**METROPOLITAN GOVERNMENT OF NASHVILLE AND DAVIDSON COUNTY**

**STAFF RECOMMENDATION**

**1109 Boscobel Street**

**Application:** New construction-infill

# SITE PLAN

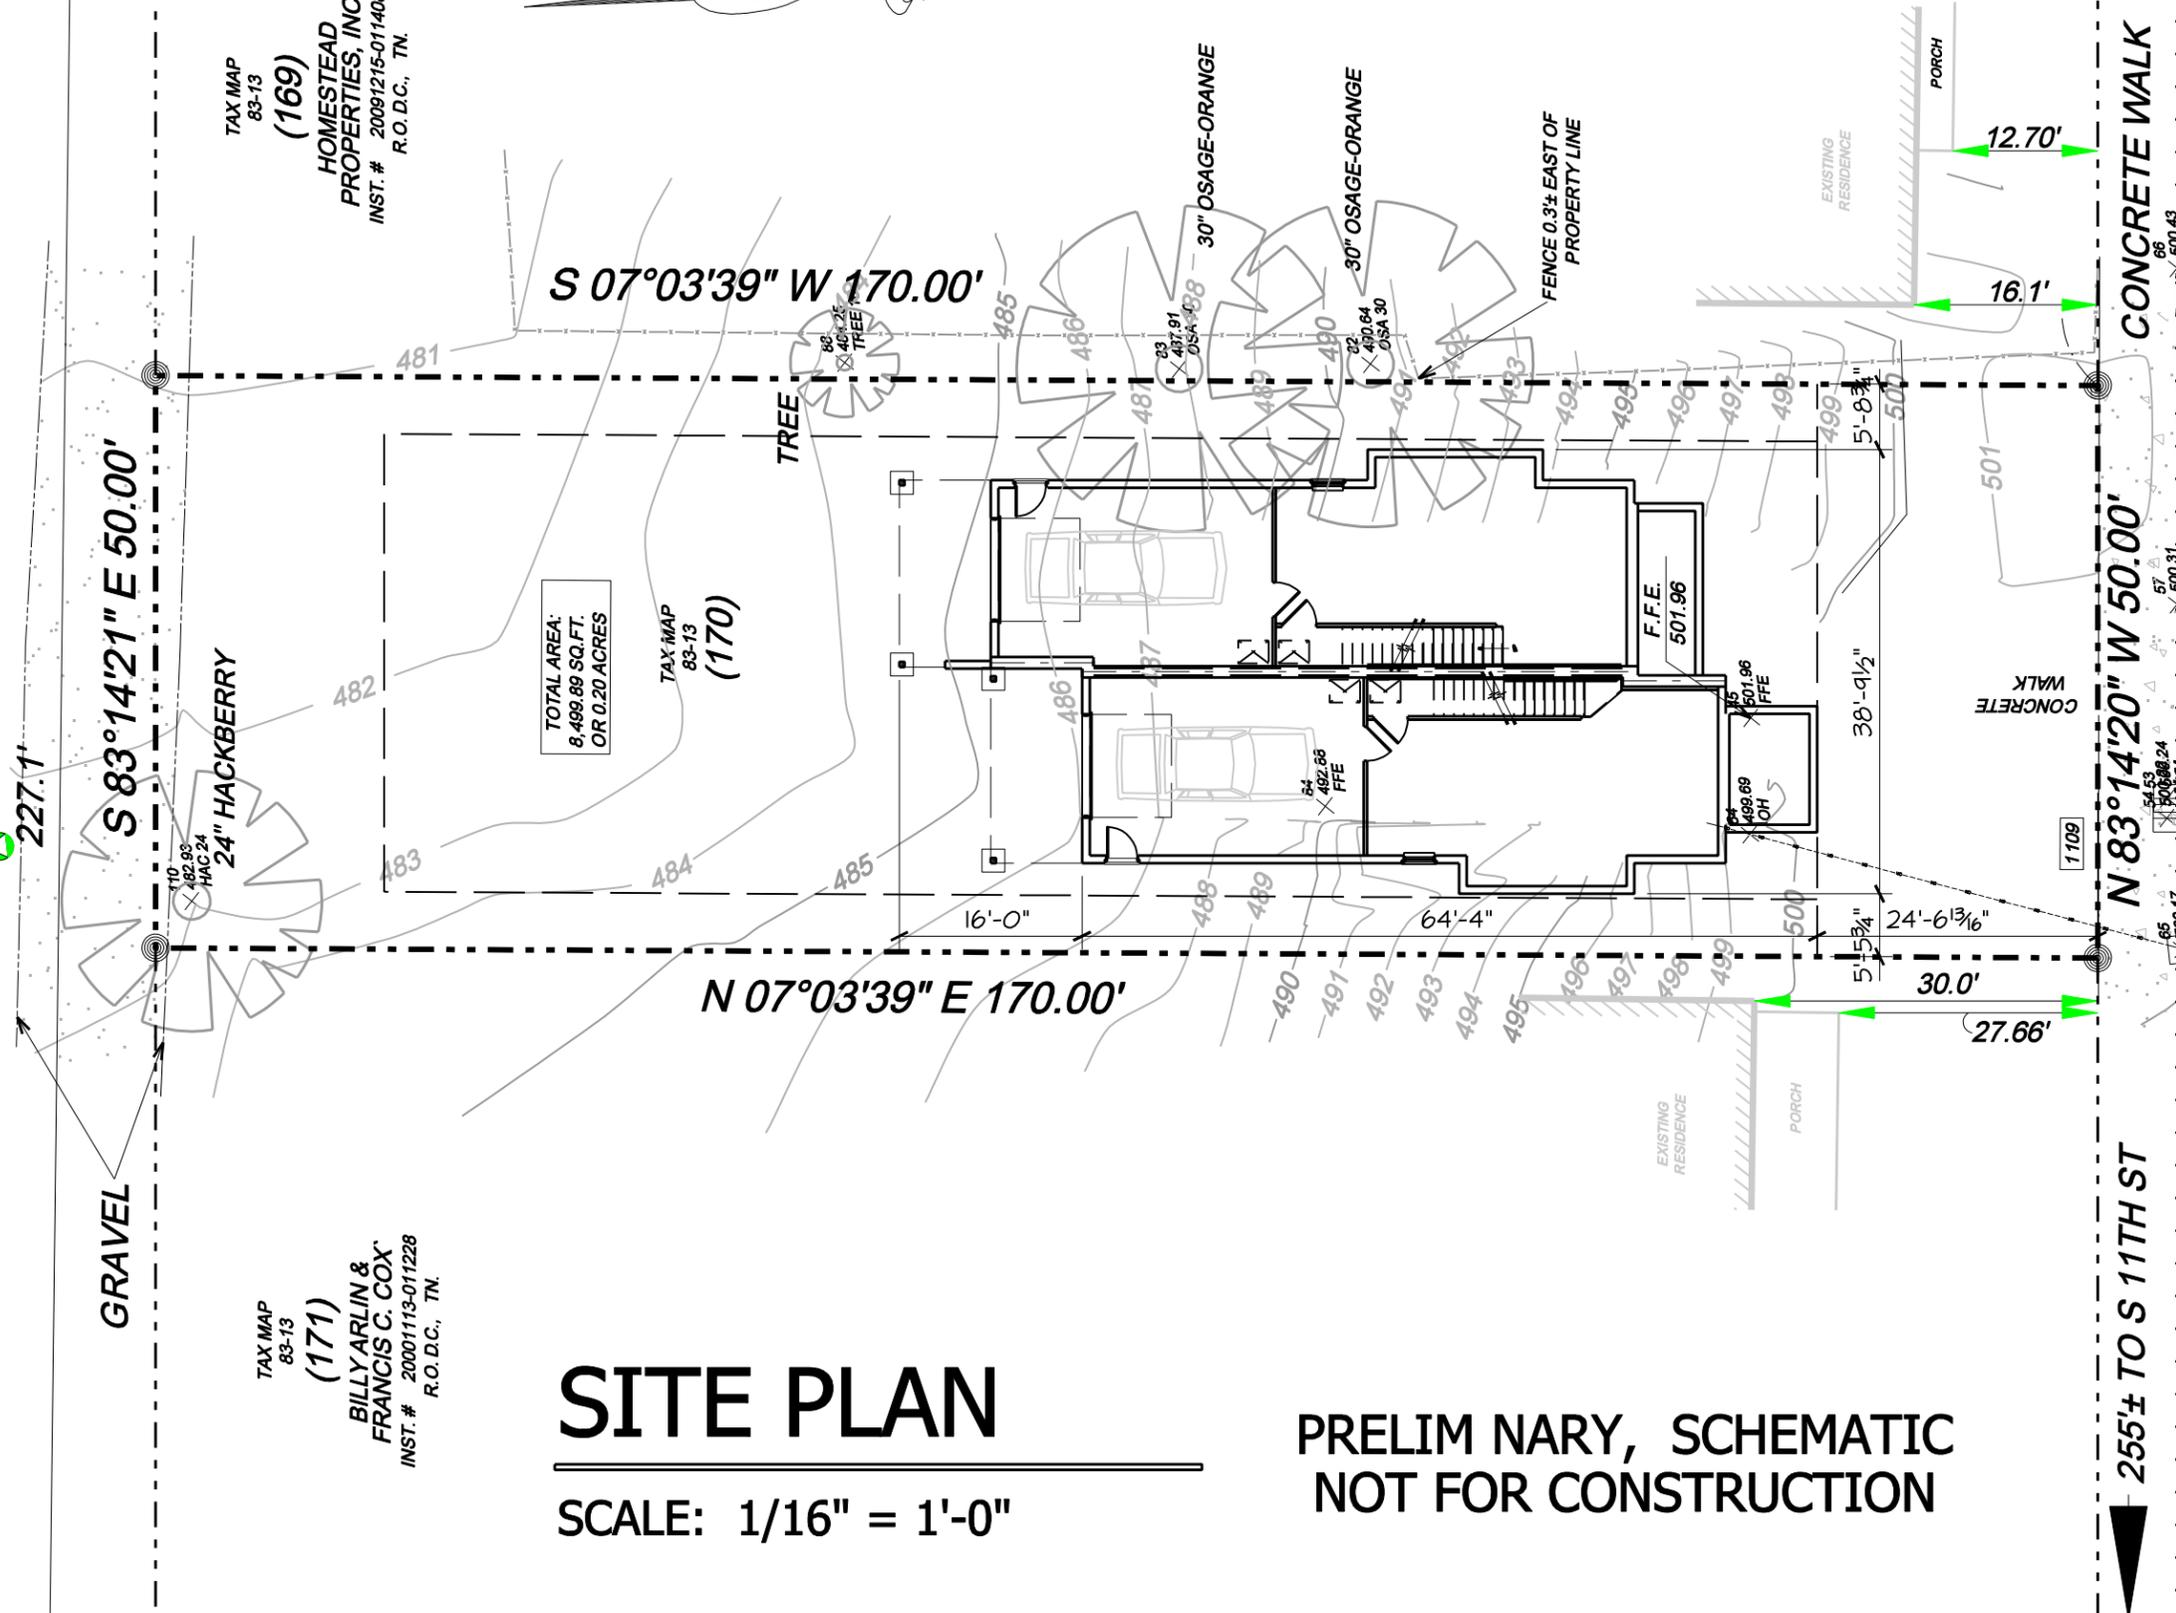
The front setback of the new building will be approximately thirty-two feet (32'), which matches the setback of the adjacent structure but is greater than the setbacks of the two

adjacent contributing structures. Staff asks that the front setback be the average of the two adjacent buildings, to be verified with a staking inspection prior to construction of the foundation.

The side setbacks for the majority of the building will be eight feet (8'), with a five foot (5') setback at the projecting side bays. These side setbacks meet the zoning requirements and will maintain the rhythm of spacing established by existing houses on the street.

The new building will be sited facing the street with two prominent front-facing porches, as is typical of historic houses nearby. The plans do not indicate a driveway. Staff recommends two concrete walkways from the two front entrances to the street. With the paving and permanent site features approved administratively, staff finds that the project meets section II.B.6.

# BASEMENT FLOOR PLAN

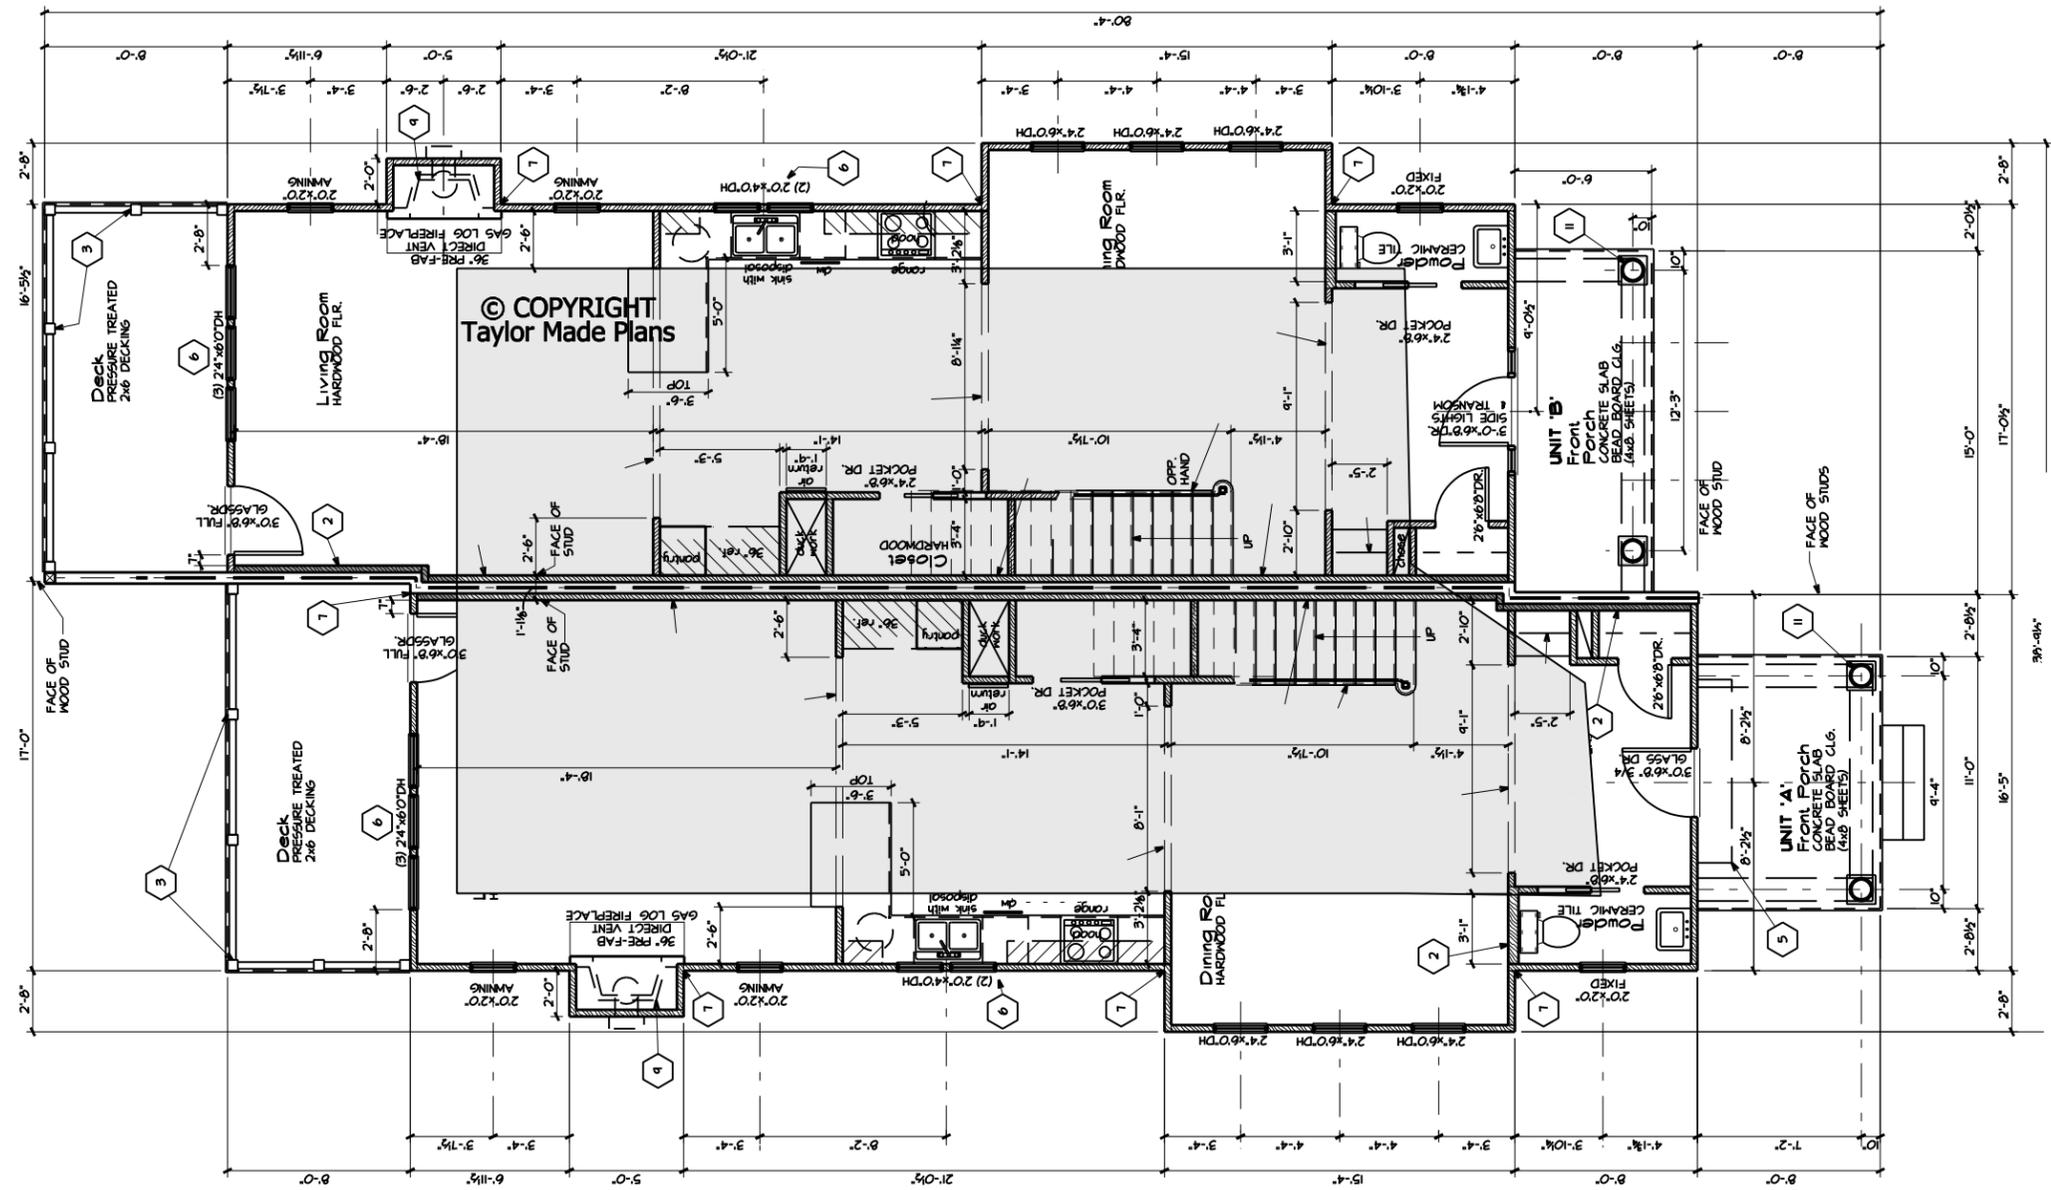
The new duplex will have garages in the basement, accessed from the alley at the rear of the lot. Basement-level garages were not uncommon in this area historically, as the grade drops more than fifteen feet (+15') from the front of the lot to the rear. Because they face the rear, the garages will not be visible from the street. For these reasons, staff finds that the attached basement-level garages meet section II.B.8 of the design guidelines.

## FRONT ELEVATION

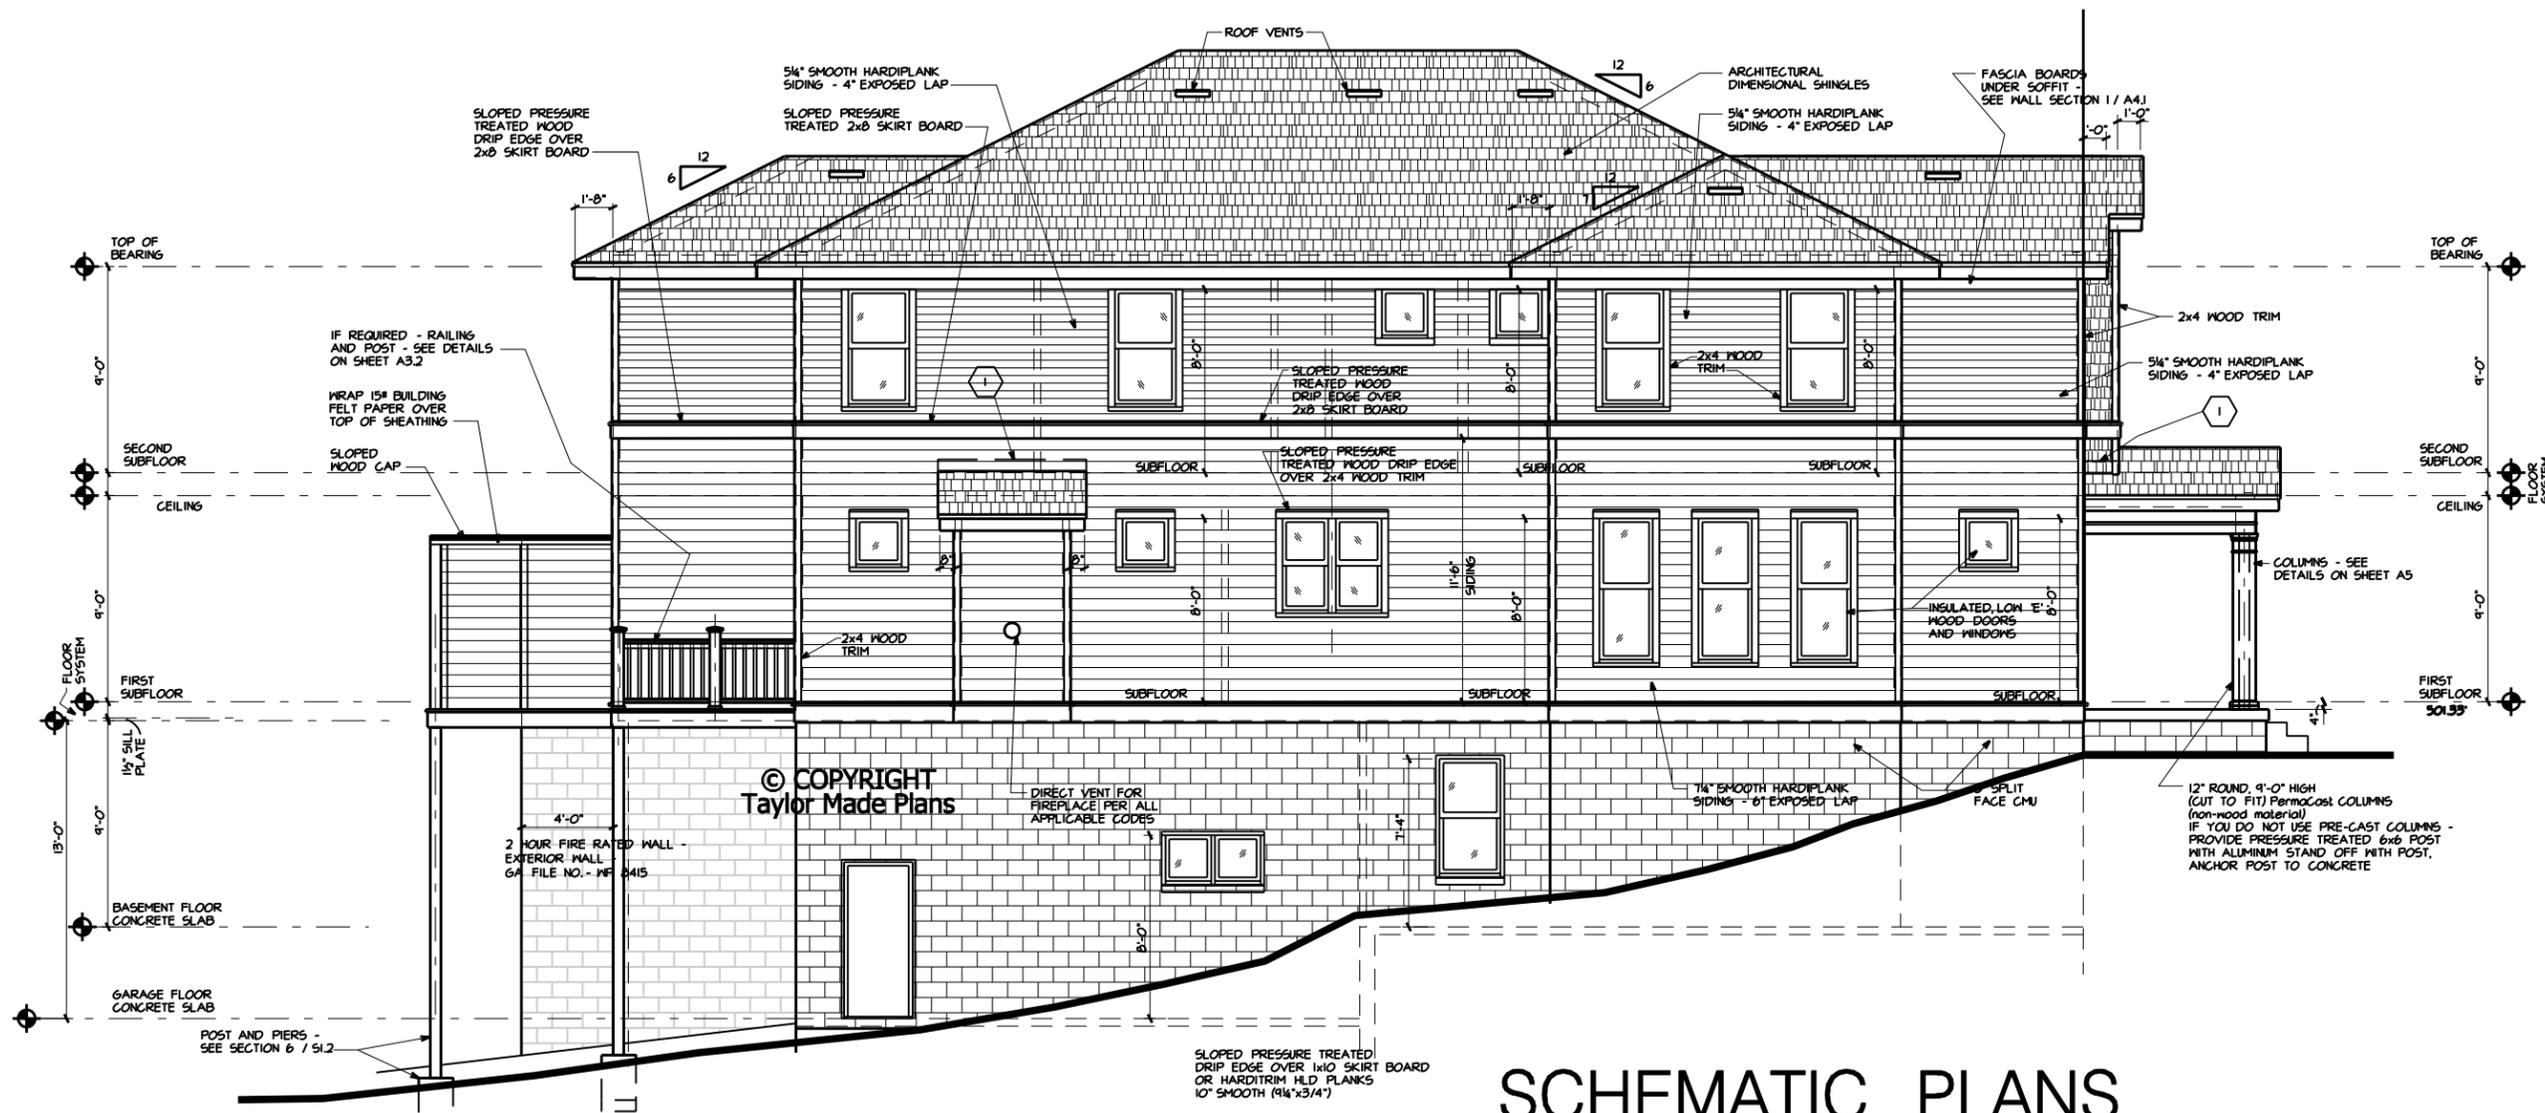
The proposed infill is a two-story two-family dwelling. The roof is hipped with a maximum height of thirty-one feet (31') tall from the ridge to the front grade. The finished floor level will be two feet (2') above grade, with a porch eave height of eight feet (8') and a primary eave height of eighteen feet, six inches (18'-6") above the floor level. Staff finds that these heights are compatible with surrounding historic structures in the area, which includes one and two-story buildings ranging from eighteen feet (18') to thirty-five feet (35') in height. Staff asks to verify that the height of the finished floor is constructed as proposed before framing begins.

The primary width of the building will be thirty-three feet, six inches (33'-6") wide, with projecting bays on both sides increasing the total width to thirty-nine feet (39'). These projecting bays will be configured asymmetrically help break up the massing, and as such only seven feet (7') of the building's overall depth will be at that full width. By comparison, houses nearby range from twenty-six feet (26') to as much as forty-feet (40') wide.

The addition will primarily be clad in smooth-face cement fiberboard with a six inch (6") reveal on the first story and a four inch (4") reveal on the second as well as cement-fiber shingles. A five inch (5") reveal is typically required for clapboard siding, but staff finds the proposed to be appropriate because the average of the two meets the requirement and because siding slightly greater than (5") has been allowed in the past when it was not the primary material. In this case, the greater reveal is only one inch (1") greater than the requirement. The trim material is not indicated. The front porch columns will be twelve inch (12") round "permacast" or 6 x 6 pressure treated wood. Staff asks to approve the permacast material prior to purchase and installation. The foundation will be split-faced concrete, and the porch floor and front steps will be poured concrete. The roof will be architectural fiberglass shingles, the color of which is not known. The windows and doors will be wood, and staff asks to approve the final window and door selections prior to purchase and installation. The rear porch materials and garage doors were not indicated. The site plan is unclear as to whether or not the existing concrete walkway will be retained. With the staff's final approval of the roof color and of the windows, doors, and porch materials staff finds that the known materials meet section II.B.4

The primary roof of the new building will be hipped with a pitch of 6:12, with the same pitch on the projecting side bays and a smaller projecting gable on the front. The front porch will have a gabled roof for the left unit and a hipped roof for the right, both with a pitch of 4:12.

The windows on the proposed new building are all generally twice as tall as they are wide, thereby meeting the historic proportions of openings. There are no large expanses of wall space without a window or door opening. Staff finds the project's proportion and rhythm of openings to meet Section II.B.7.
